PLANNING COMMISSION AGENDA

RE: Proposed Lampson Subdivision, Landscaping, Forest Conservation and Subdivision plan review cursory

DEPARTMENT OF PLANNING STAFF REPORT

PROJECT: Subdivision Plan for Parcel N-Section two of Bulle Rock

Attachment 1

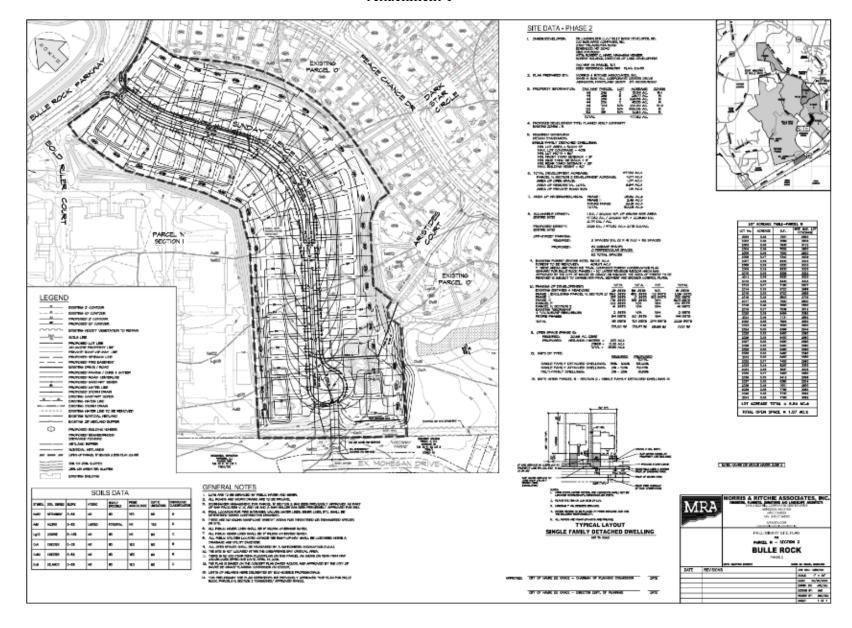
The Department of Planning recommends **APPROVAL** of the Preliminary Subdivision Plan subject to the conditions outlined below. Additional comments and conditions of approval will be forwarded to the consultant upon approval of subsequent plans submissions.

- 1. The final plats shall be recorded in the Harford County Land Records prior to building permit application for any residential unit. The final plats shall be prepared in accordance with the City's final plat checklist and the requirements of Section 173-16 of the City Code.
- 2. The final plat shall include the addresses for all units as shown on the addressing plan that will be forwarded to the Engineering consultant.

- 3. Based on the comments made by citizens during previous meetings, the Department requests that consideration be given to planting a landscape buffer between the rear of these lots and those existing dwellings fronting Peace Chance Drive and Aristides Court.

- 5. The Road Plans shall have the following statement included as a standard note "Cul-de-sacs shall be constructed to facilitate suitable turning movements in accordance with the National Fire Protection Association (NFPA) requirements contained within Part 1 and 1141."

- 7. In accordance with Section 174-14.A(5) of the Subdivision Regulations, sidewalks shall be constructed for all new developments, specifically Parcel N. In lieu of sidewalks, a connected trail system that is in line with the attached "COMMUNITY TRAIL" system map approved by the City must be indicated on drawings and constructed along Bulle Rock Parkway, as shown in orange on the above mentioned map, adjacent to Sunday Silence Court for the future residents of Parcel N.

- 1. Water and sewer plans must be designed in accordance with the Harford County Water and Sewer Standard Specifications and Details and approved by the Department of Public Works prior to approval of the grading permit.
- 2. All sanitary manholes must be spaced 300-feet apart.
- 3. The existing water line at the entrance to Sunday Silence Court shall be replaced back to the existing valve.
